Office Action Summary

10/600,479

DETAILED ACTION

2. Claims 1-3 and 6-9 are rejected under 35 U.S.C. 103(a) as being unpatentable over Nicholson (GB 2364558 A) in view of Noboru et al. (JP 11-153180).

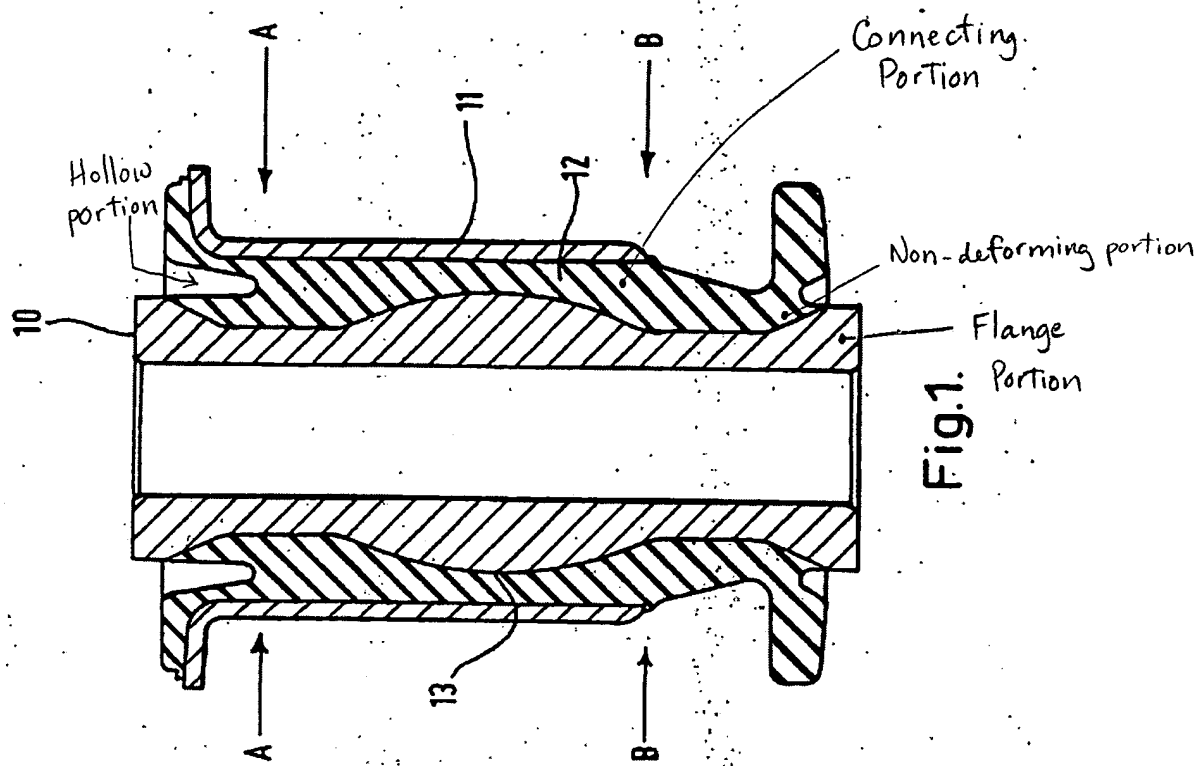
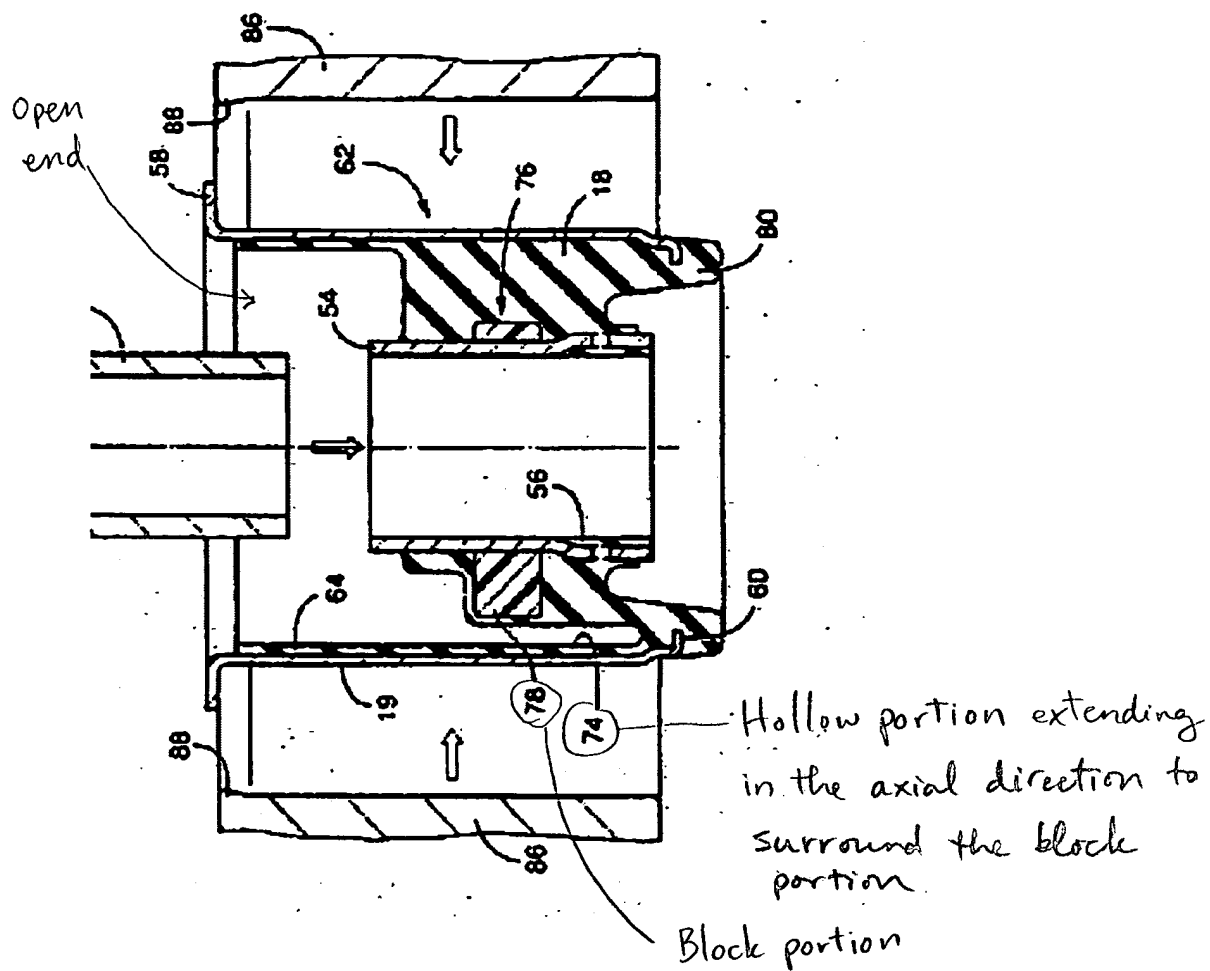
Re: claim 1, Nicholson shows a vibration isolating bushing in figure 1, as in the present invention, comprising: a main shaft member 10 including a tubular portion, a flange portion, as marked below, extending radially outwardly from one end of the tubular portion, and a block portion 13 provided on a central portion of the tubular portion and distanced from the flange portion in an axial direction of the main shaft member; an outer cylinder member 11 disposed coaxially on an outer side of the main shaft member in a distance therefrom; and a rubber elastic body 12 disposed between the main shaft member and the outer cylinder member integral connection of the main shaft member and the outer cylinder member, said rubber elastic body including a hollow portion, as marked below, which is open in an end face away from the flange portion and extends in the axial direction; wherein the rubber elastic body further includes non-deforming rubber portion, please see the figure below, and a connecting portion, see the figure below; the non-deforming rubber portion fills a gap between the

flange portion and an end face of the block portion facing the flange portion in the axial direction and is substantially undeformable with respect to an application of an axial load; the connecting portion is positioned between a bottom the hollow portion and the end face of the rubber elastic body on the side of the flange portion, for connecting the non-deforming rubber portion and an inner peripheral surface of an end portion of the outer cylinder member. Nicholson is silent of the cross-sectional shapes of the hollow portion and the block portion as claimed. Noboru et al. teach a vibration isolation bushing, especially a cross-sectional shapes of a hollow portion and a block portion, in figures 2 and 4. In figure 4, the hollow portion 74 extends to a vicinity of an end face of a block portion 78. In figure 2, the hollow portion 74 directly surrounds the block portion extending circumferentially and over a side surface to the main shaft member 56. It would have been obvious to one of ordinary skill in the art at the time the invention was made to have modified Nicholson's bushing with cross sectional shapes of a hollow portion and a block portion such as taught by Noboru et al. in order to provide a softer ride since it is well known in the art of dampening to change the spring constant of the elastomer member in order to achieve a desired dampening results as evidenced by Norobu et al.

【图 2】

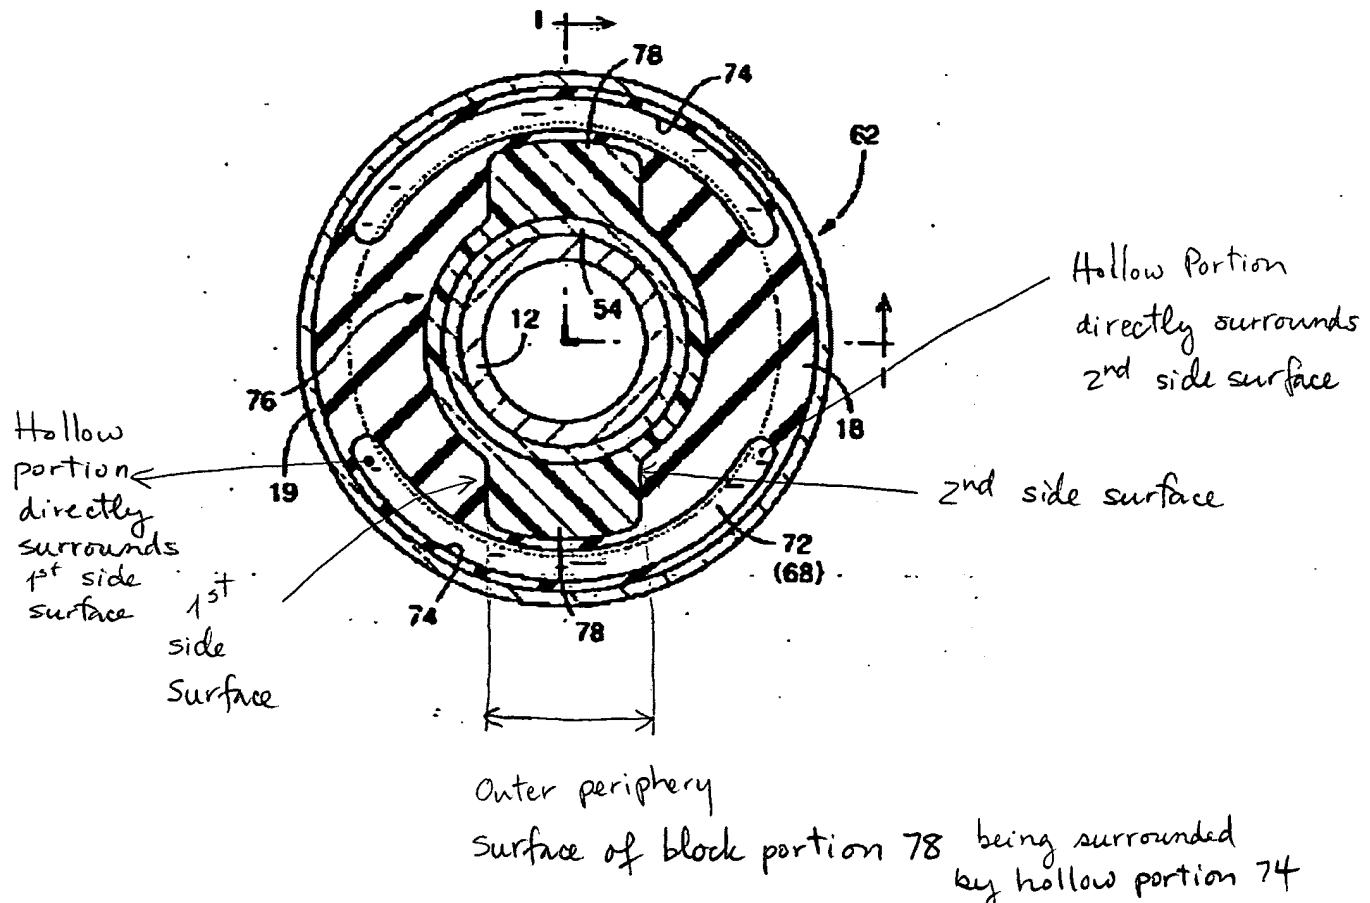
Re: claim 6, Noboru shows in figure 4 hollow portion 74 directly surrounds the side surface which extends along the axial direction, see marked up figures above.

Re: claims 7-9, Noboru further shows a second side surface of block portion 74 extending from the radial outer peripheral surface to the main shaft member 56; and the hollow portion 74 directly surrounds the second side surface which extends along the axial direction as marked above. Furthermore, the second side surface of the block portion 78 is parallel to the first side surface as shown in figure 2 of Noboru.
